ARCHITECTURAL REVIEW BOARD

REGULAR MEETING MINUTES

148 Bal Bay Drive, Bal Harbour FL, 33154

SUBJECT: 148 Bal Bay Dr
New Two-Story Single-Family Residence (Deferred on December
4th, 2025 - Resubmittal)

Building Sections

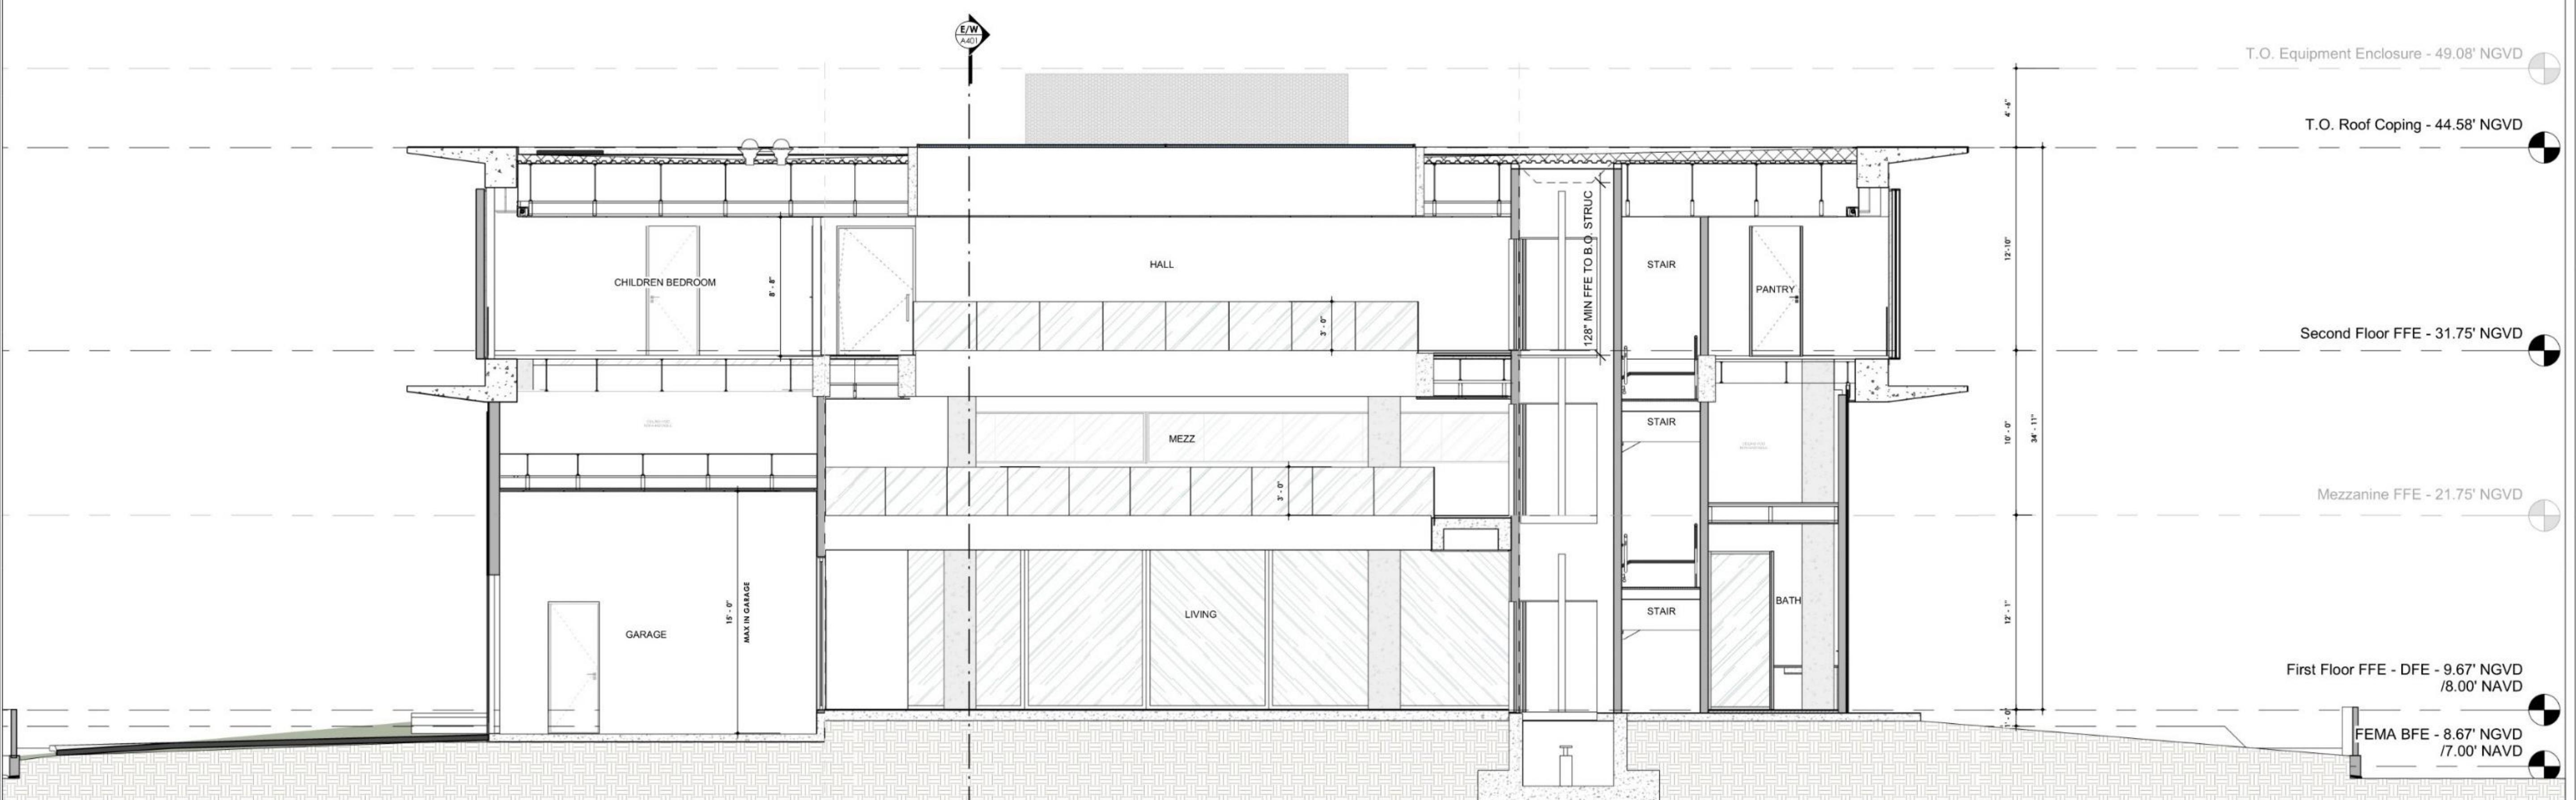
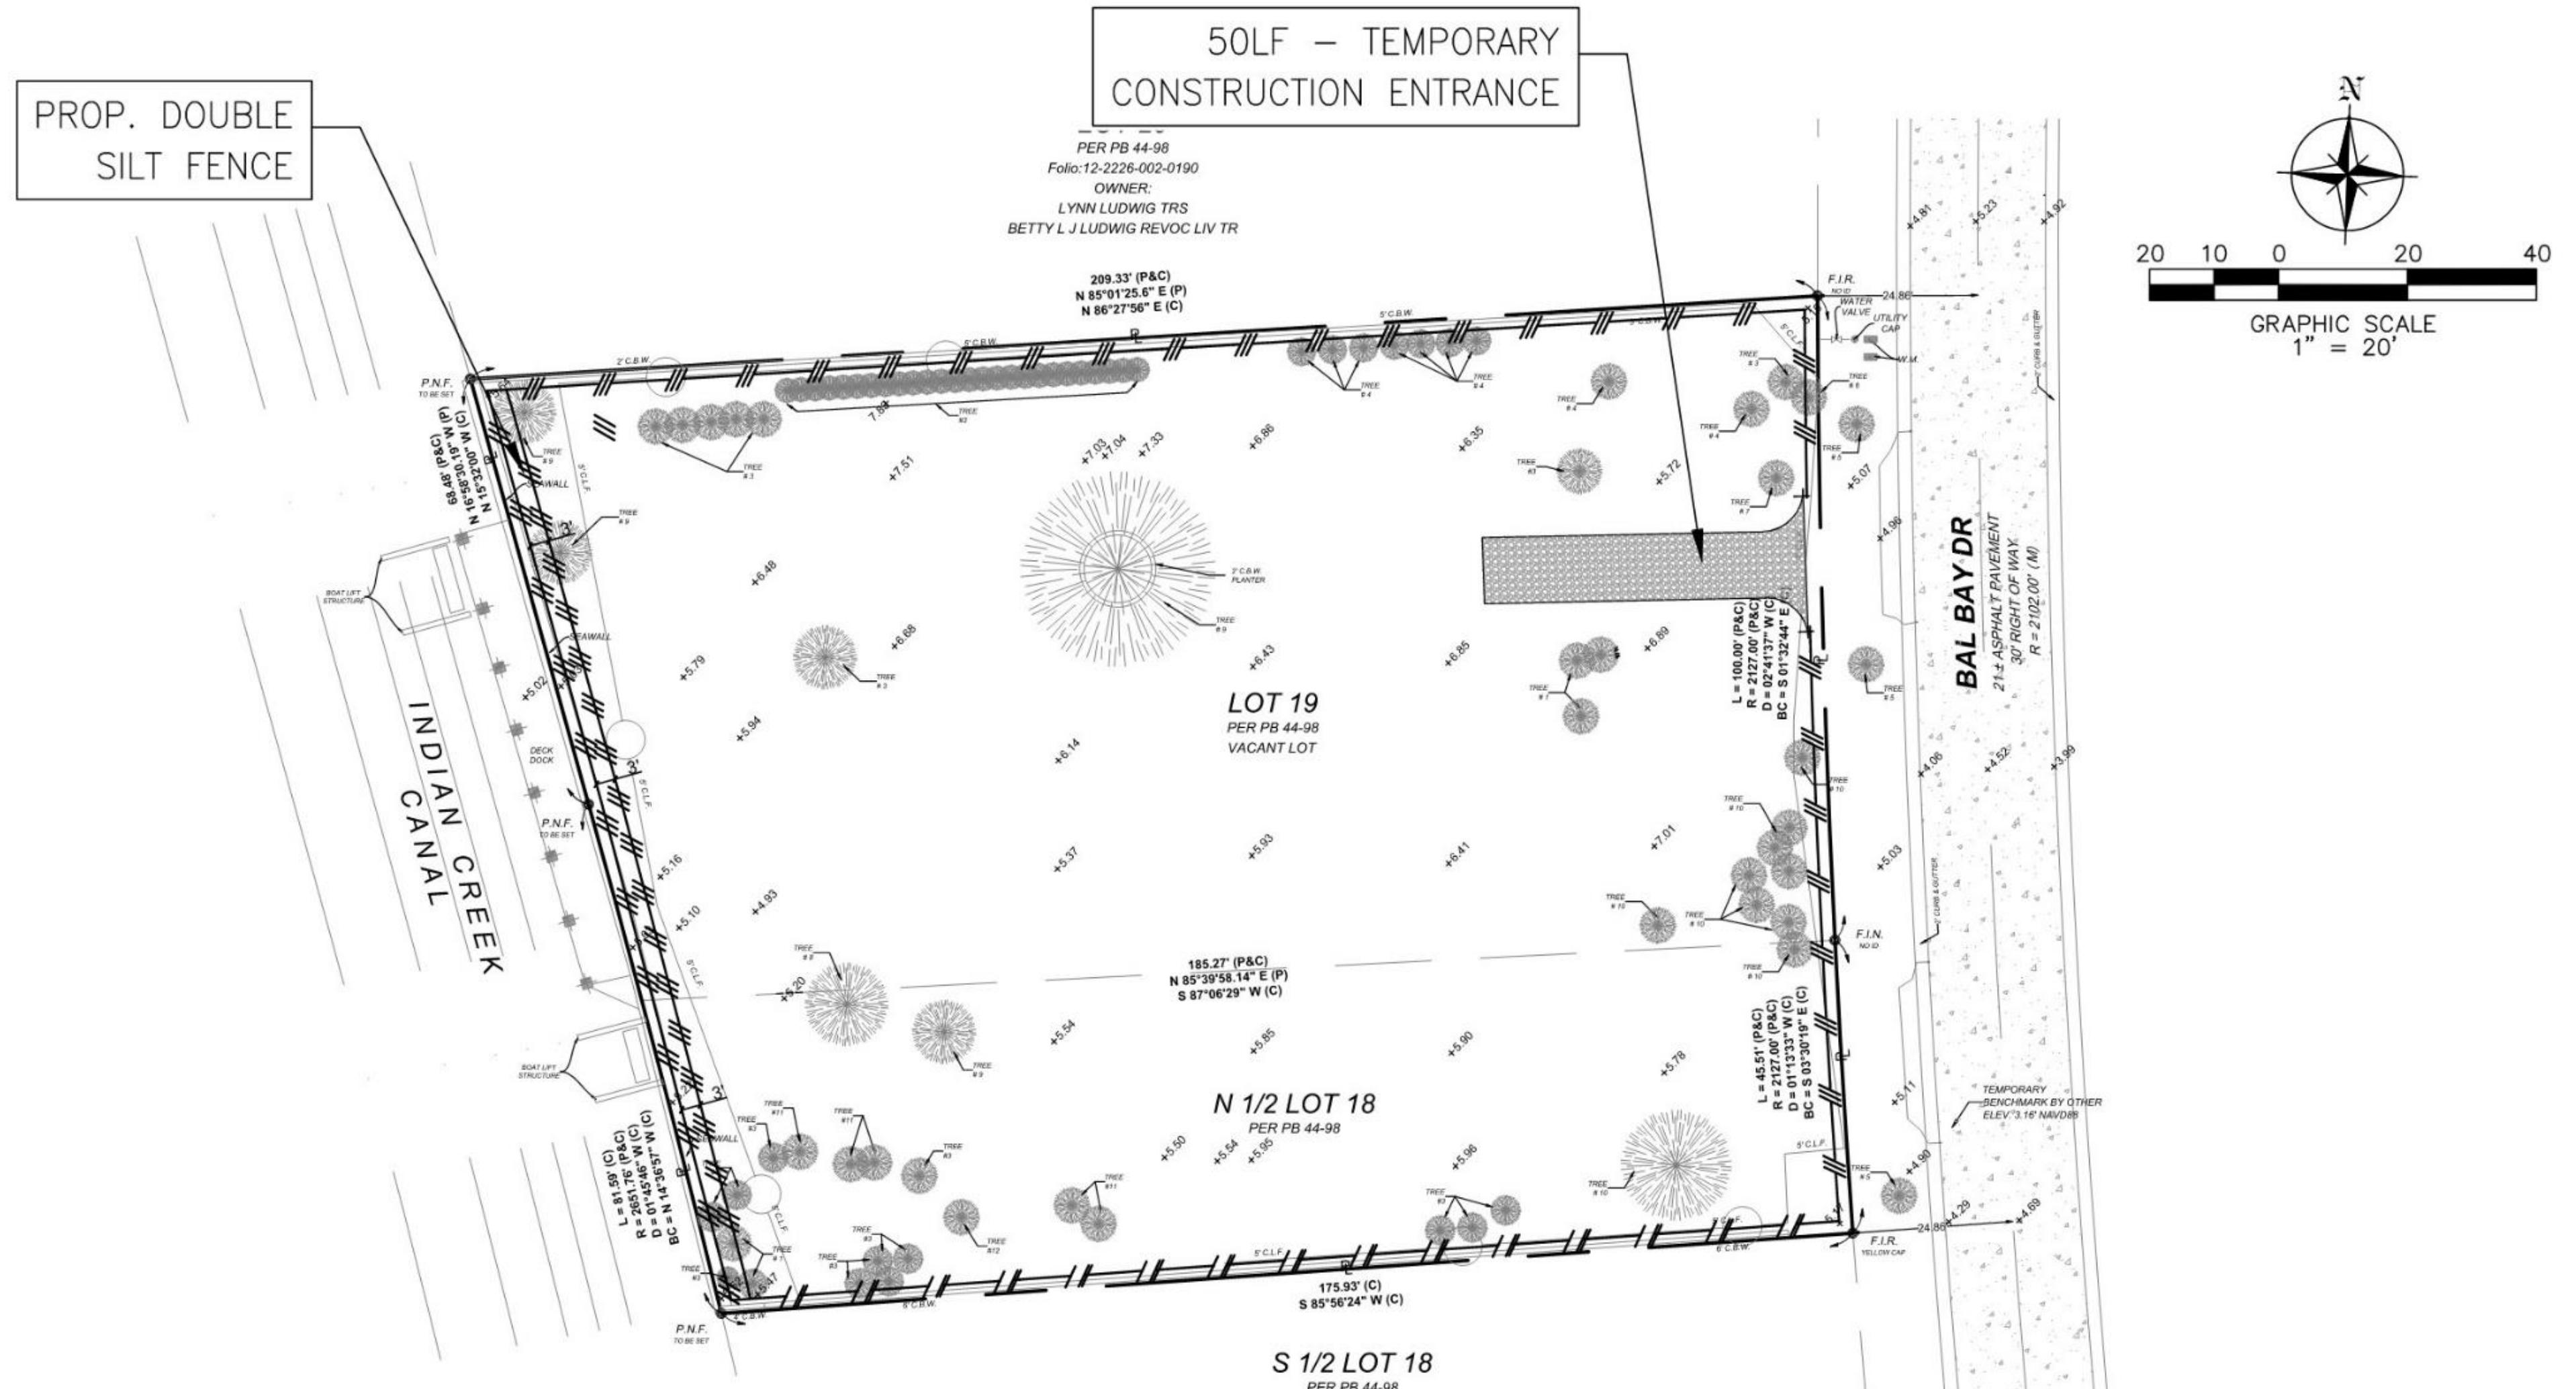
Chair Borges said that he would like to see a section showing the mezzanine relationship to floors and ceiling heights.

There was a general consensus from the ARB to have the applicant submit a building section because the mezzanine was central to both how the house would be perceived and how it would be classified, and that plans alone couldn't prove those vertical relationships.

Chair Borges re-stated the Board wanted the applicant to return with further detailing on the edge canopy system and the integration of sliding versus folding doors. Mr. Gomez added that clear north-south and east-west sections were needed to show mezzanine logic, elevator override.

This submission also complies with the request from the Board from the previous Hearing for more information showing the massing of the two-story building.
